Job Number: 06-7128

Subject: Subsoil and Foundation
Investigation Review, Site Grading &
Pavement Recommendations, 5th & Yampa
Project, Lots 10-12, Block 27, Original
Town of Steamboat Springs, Colorado.

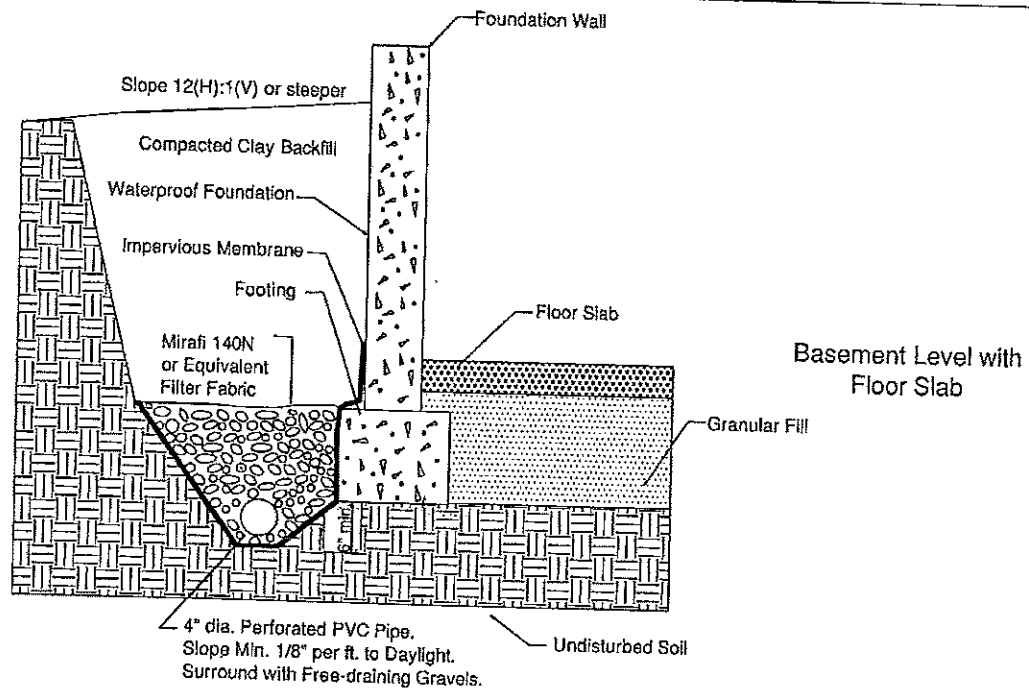
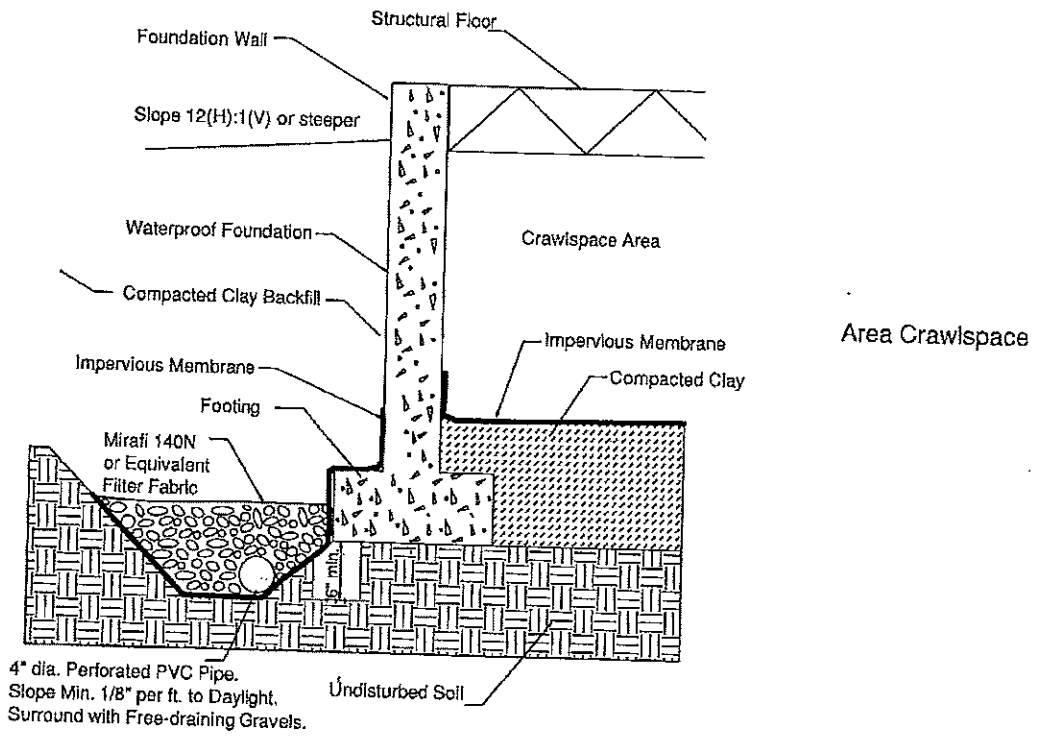
Based on the proposed construction, we recommend that the Underdrain System recommendations outlined in the original Geotechnical Investigation be replaced with the following:

Underdrain System: The lower levels of the proposed building structure should be protected by perimeter/underdrain systems to help reduce the problems associated with surface drainage during high runoff periods and the groundwater table. Ideally, the concrete slabs in the lower levels of the structures and parking garage should be placed a minimum of 2 feet above the seasonal high groundwater level. However, based on our understanding of the proposed construction and the depth to groundwater at the site, it does not appear that placing the lower level above the groundwater table will be feasible.

The underdrains should be located around the entire perimeter of the buildings and be placed at least 2 feet below the lower floor slab elevation. In addition, the placement of at least two feet of free draining gravels and lateral drainpipes under the floor slabs will need to be installed. The actual spacing, depth and size of the lateral drains should be determined after the building excavations have been completed and the amount of groundwater seepage/flow can be determined.

We recommend the use of perforated PVC pipe for the drainpipes, which meets ASTM D-3034/SDR 35 requirements, to minimize the potential for crushing the pipe during backfill operations. The drainpipe should be surrounded by at least 12 inches of free draining gravel. The holes in the drain tile should be oriented down between 4 o'clock and 8 o'clock to promote rapid runoff of the water. The drain tile system should be protected from contamination by a filter covering of Mirafi 140N subsurface drainage fabric or an equivalent product. The drain should have a minimum slope of 1/8 inch per foot and be led to sump pits from which the water can be pumped. Three or more sump pumps and pits should be considered for the proposed structure. Caution should be taken when backfilling these areas so as not to damage or disturb the installed underdrain. We recommend the drainage system include at least one cleanout for every 100 lineal feet of pipe, be protected against intrusion by animals at the outfall and be tested prior to backfilling. A typical perimeter/underdrain detail is shown in Figure #1.
